APPEAL SUMMARY

Appeal ID: 25059	Project Address: 2701 NW Vaughn St
Hearing Date: 8/11/21	Appellant Name: Tom Jaleski
Case No.: B-012	Appellant Phone: 5034885651
Appeal Type: Building	Plans Examiner/Inspector: Brett Hulstrom
Project Type: commercial	Stories: 10 Occupancy: A-2, A-3, S-1, S-2, M, B Construction Type: I-A
Building/Business Name: Montgomery Park	Fire Sprinklers: Yes - NFPA 13 Throughout
Appeal Involves: Alteration of an existing structure, Addition to an existing structure	LUR or Permit Application No.:
Plan Submitted Option: pdf [File 1]	Proposed use: Office, Retail & Dining

PROJECT
MONTGOMERY PARK
REPOSITIONING
2701 NW VAUGHN STREET
PORTLAND, OR 97210

A101

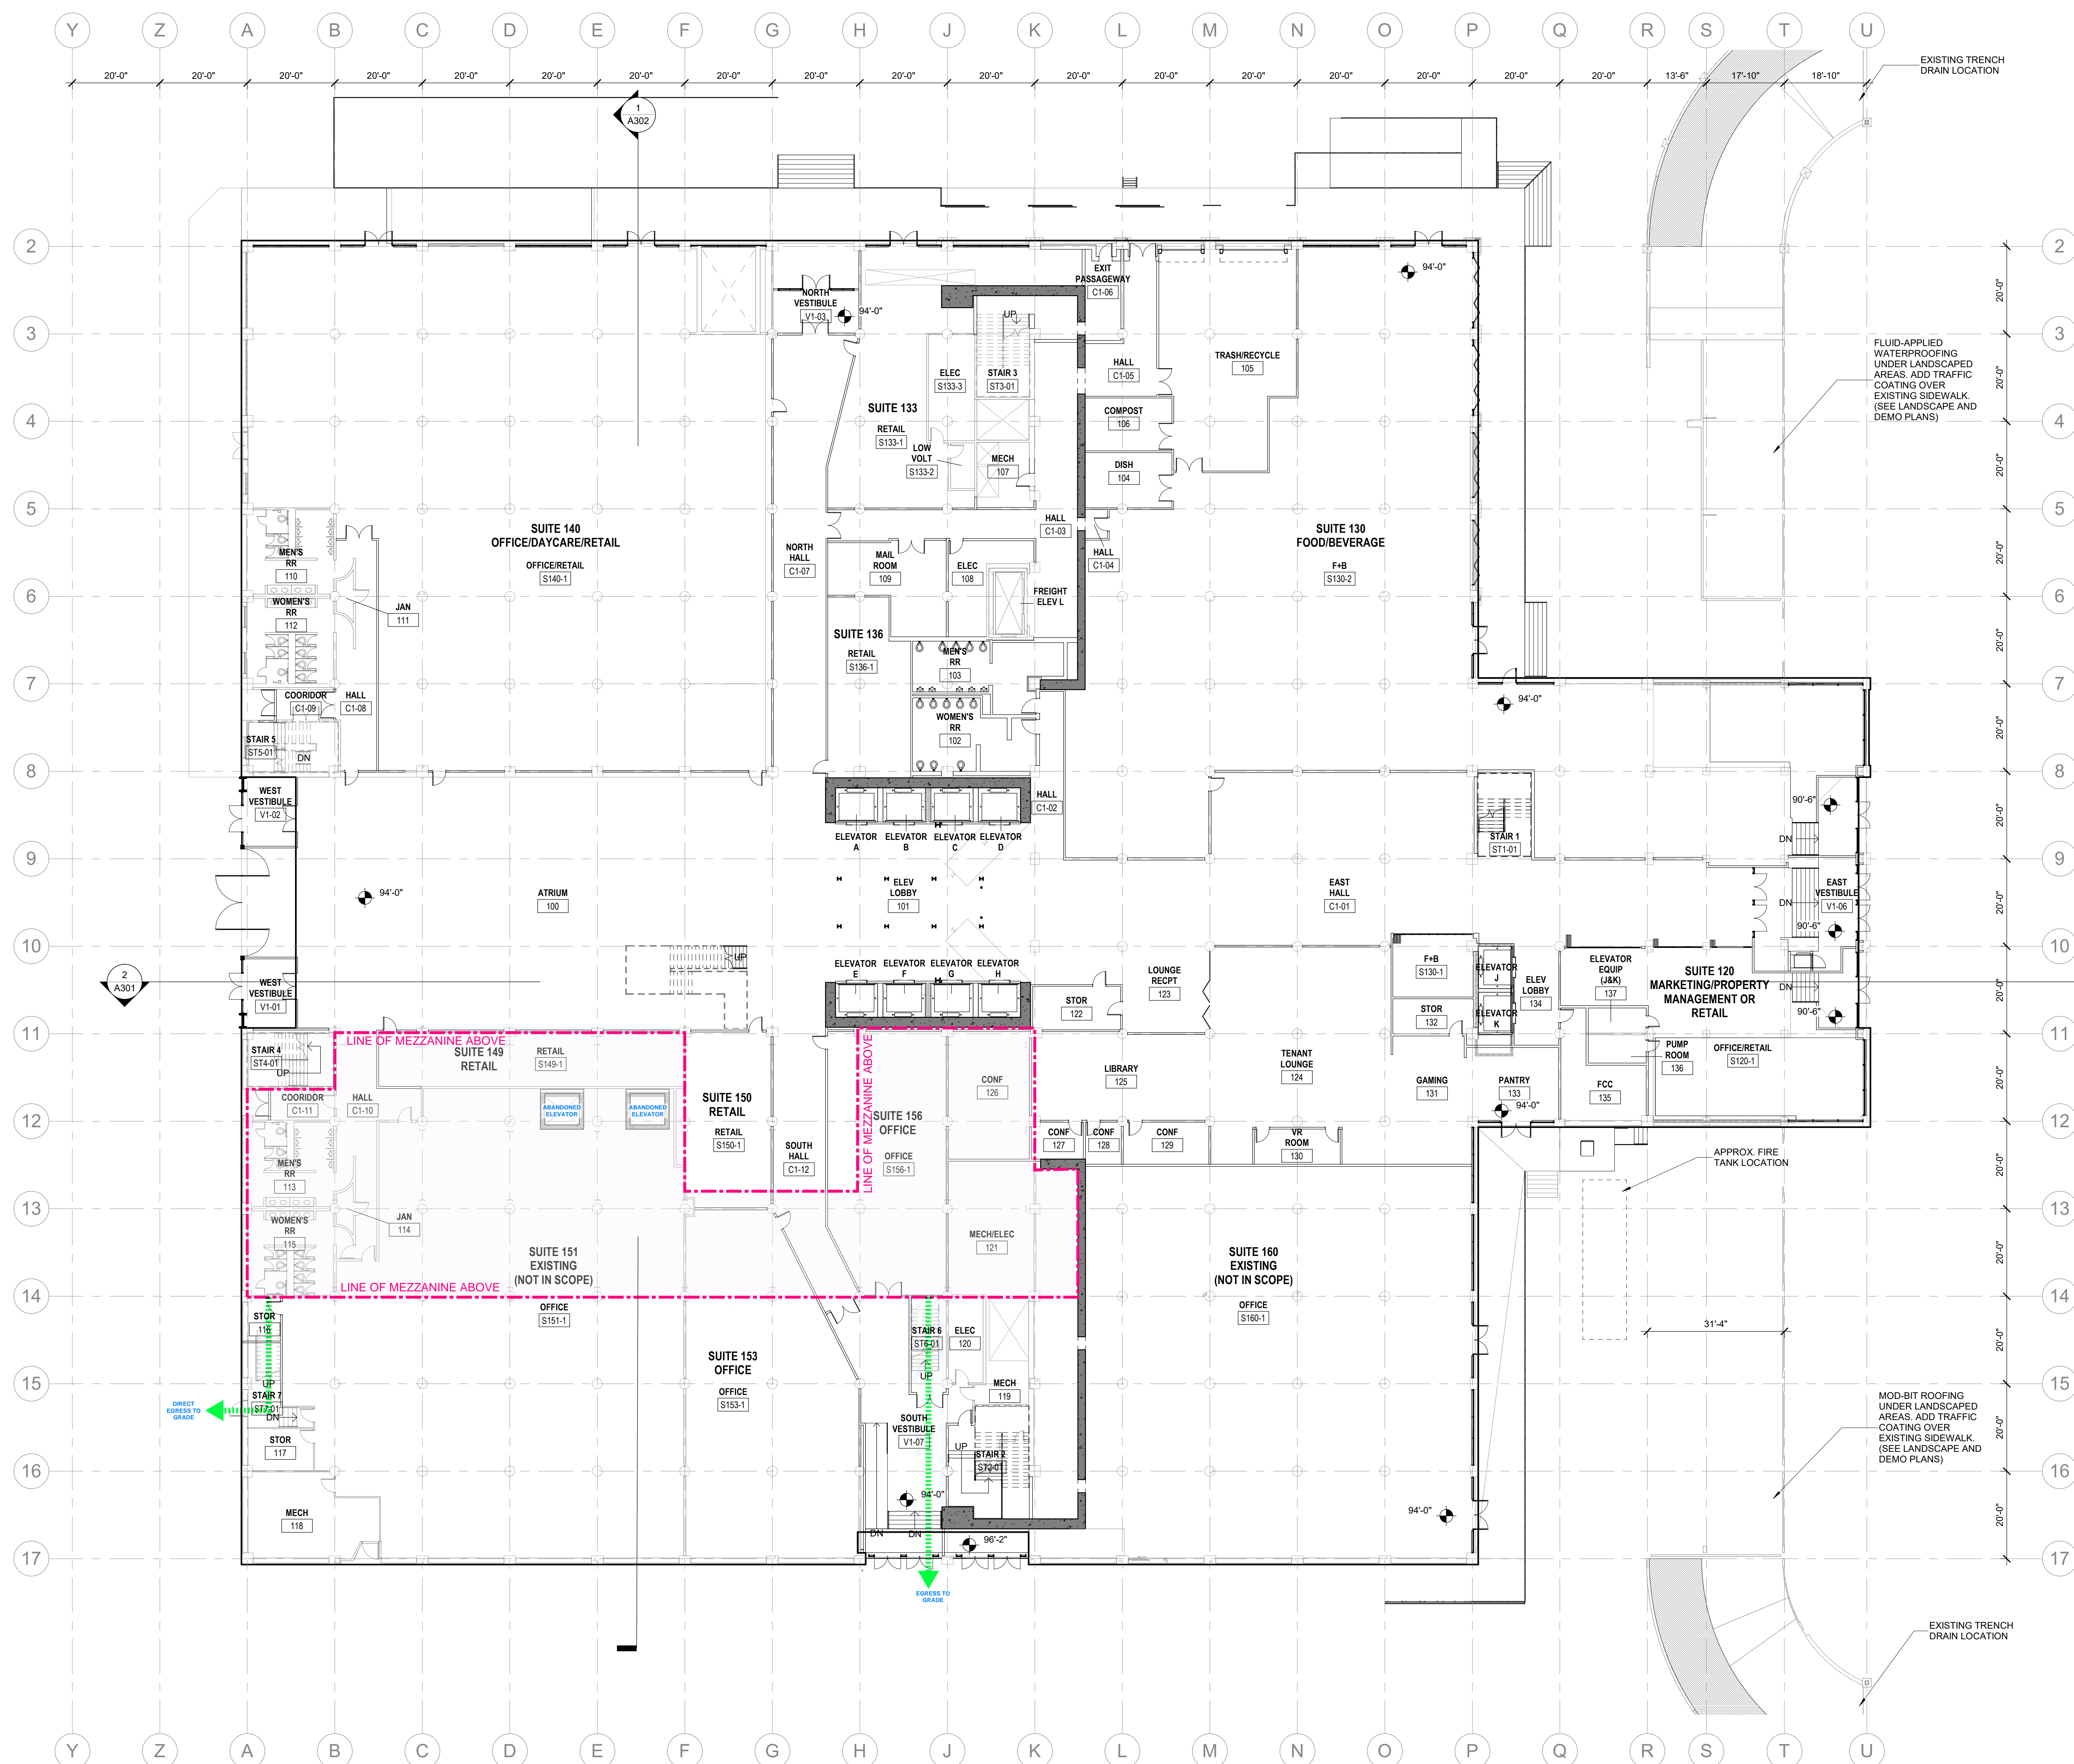
A fully sprinklered, enclosed mezzanine 9,200 s.f. in size exists between levels 1 and 2. This mezzanine contains mechanical equipment and storage rooms only accessed by building maintenance personnel. The mezzanine has 2 stairs that serve as means of egress to level 1. See attached sheets A090, A101, and A101M for building plans, including egress routes from mezzanine, A301 and A302 for sections showing mezzanine, and A601M for enlarged plan showing functions of the spaces on the mezzanine.

- 1. Omission of fire service access elevator from a 9,200 sf existing 1st floor mezzanine: Granted as proposed for this use and configuration.**
- 2. Omission of ambulance stretcher-sized elevator car from a 9,200 sf existing 1st floor mezzanine: Granted as proposed for this use and configuration.**
- 3. Omission of fire service access elevator from proposed occupied roof deck: Hold for additional information. See note below regarding the process for submitting additional information.**

A110

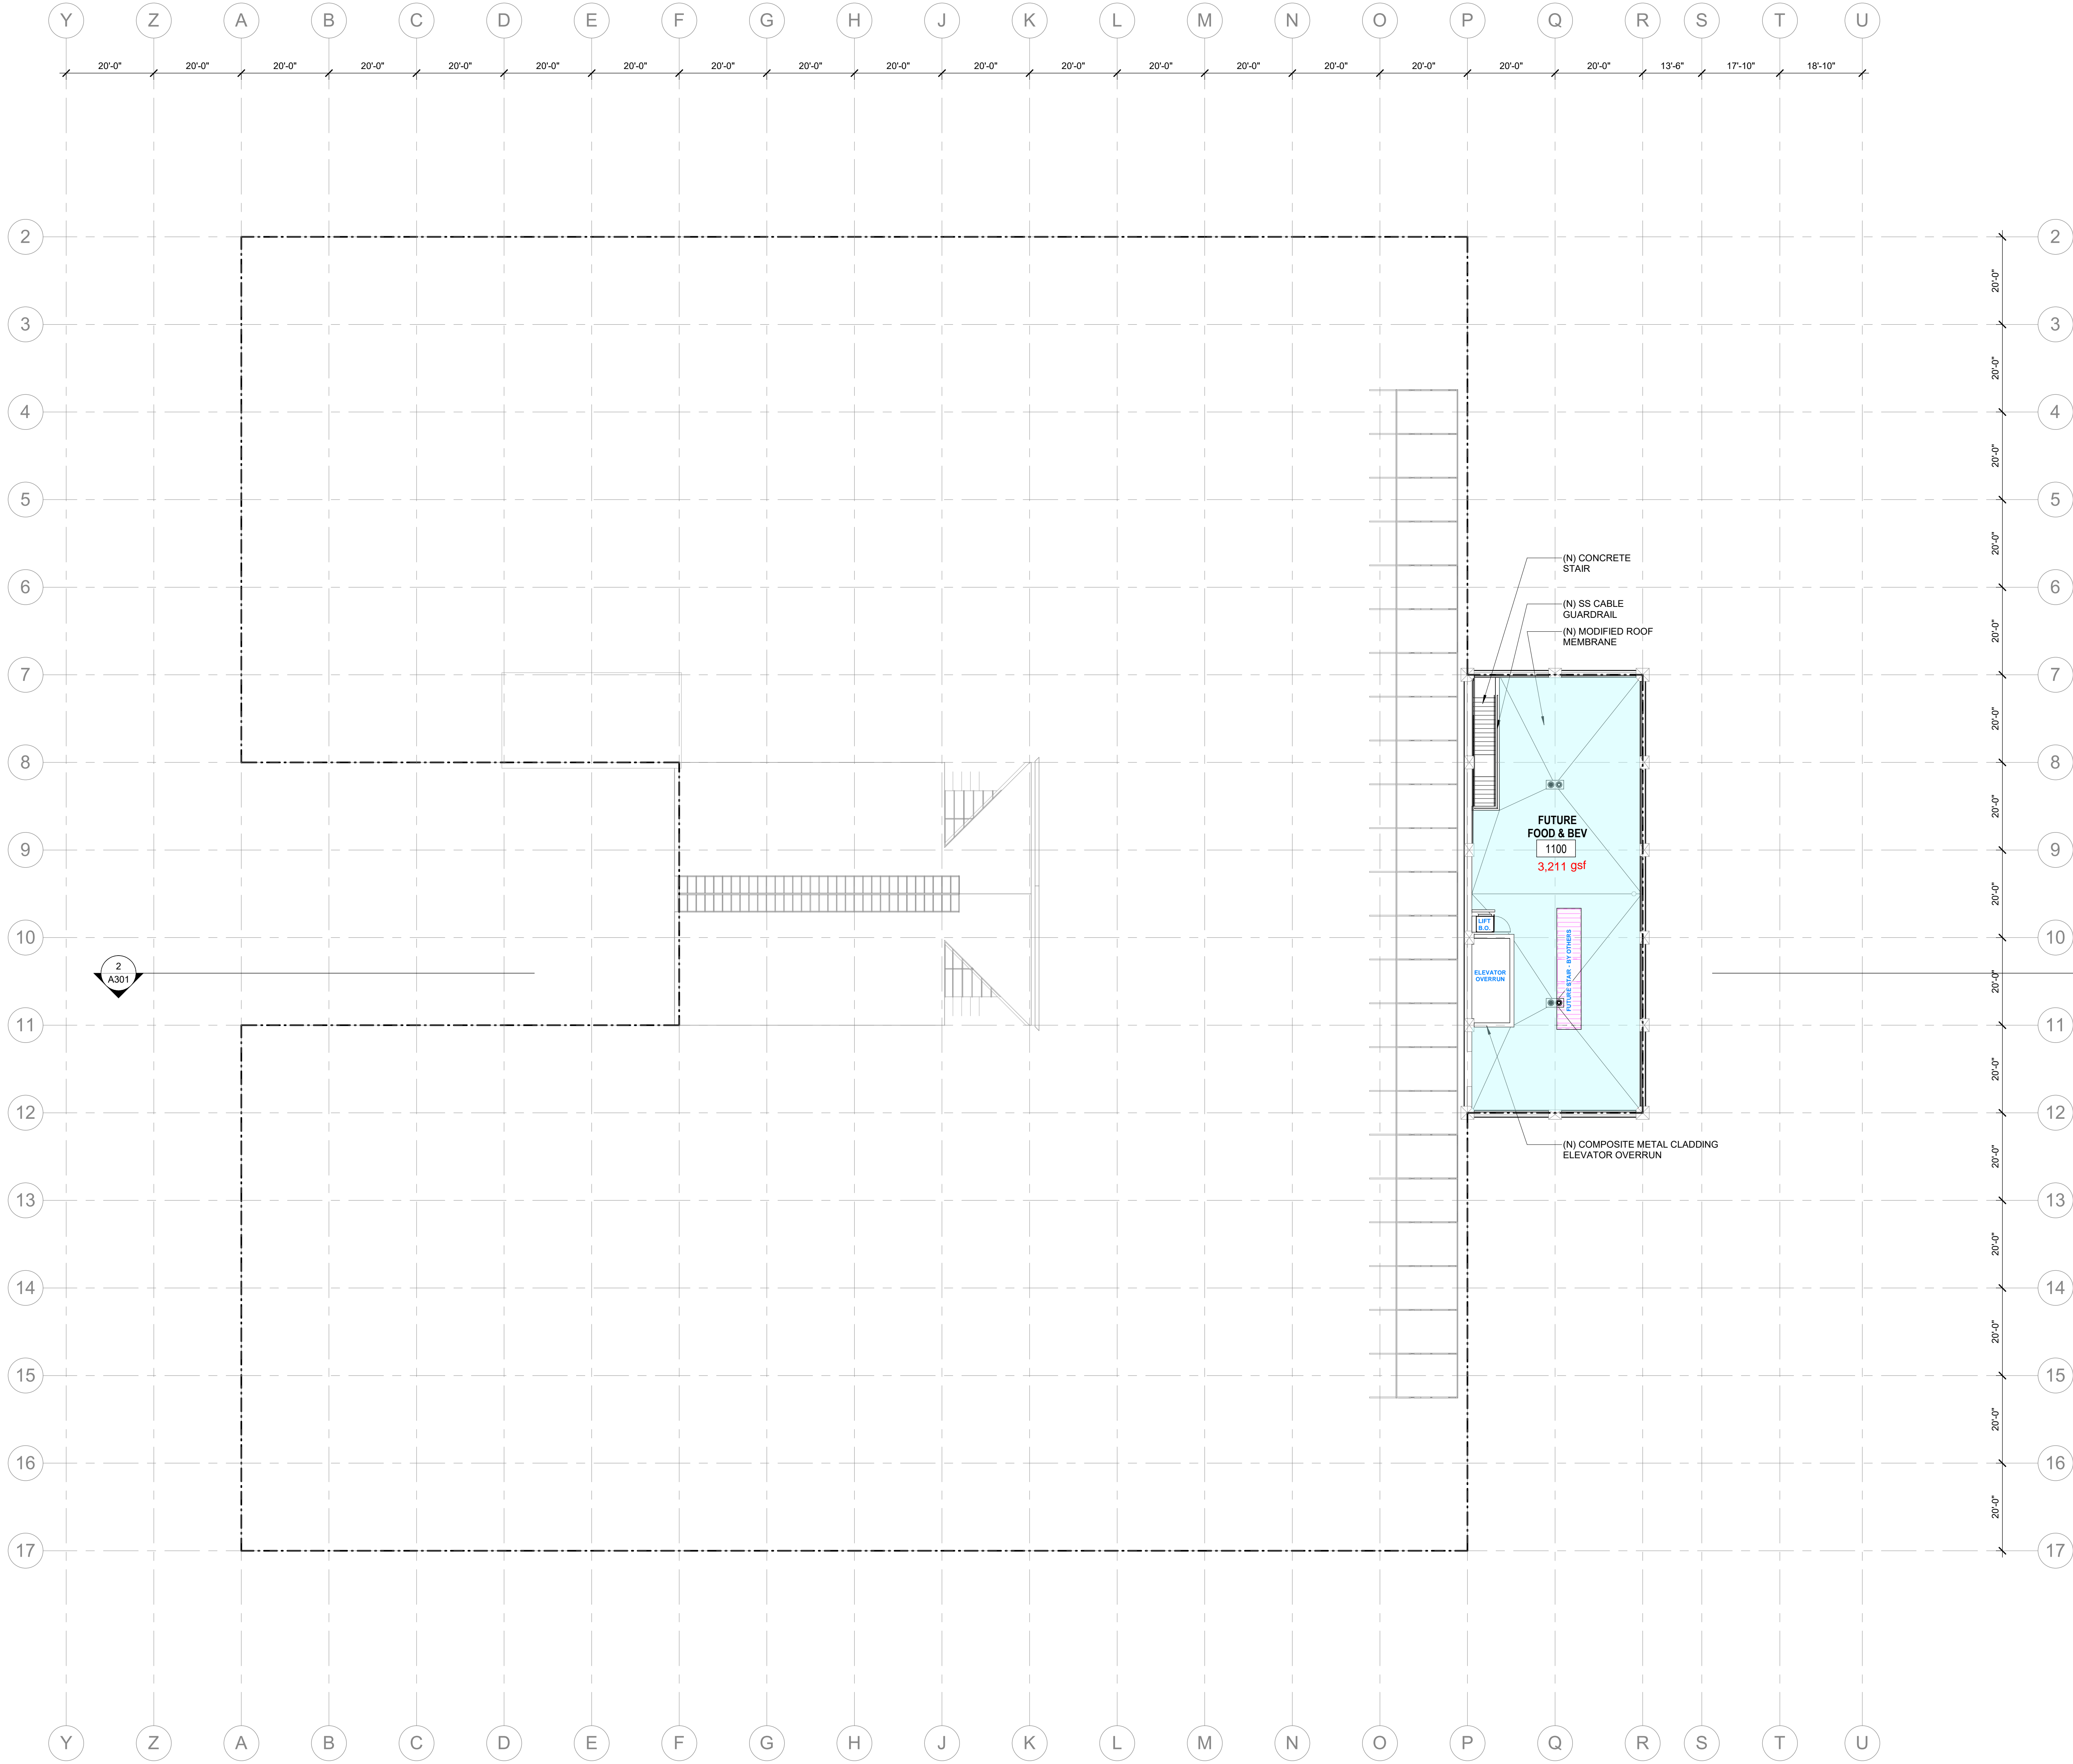
A 3,250 s.f. occupied roof deck will be new to the existing building, above the existing 10th story. The roof exists, but occupant access to and use of the roof is proposed to be a new addition to the building. This roof deck meets the requirements for an occupied roof per OSSC with no enclosures exceeding 48" in height. The Fire Service Access Elevator (FSAE) cannot extend to this occupied roof area because of the historic designation of the building prohibits competing with the view of the well-known neon sign above the occupied roof area. The roof deck has 2 stairs that serve as means of egress to level 10. See attached sheets A090 for building plan, A110 for enlarged plan showing level below occupied roof with FSAE, lobby, and stair locations from occupied roof, A111 for enlarged plan showing functions of the spaces on the occupied roof, and A301 for section showing occupied roof and maximum height possible for FSAE.
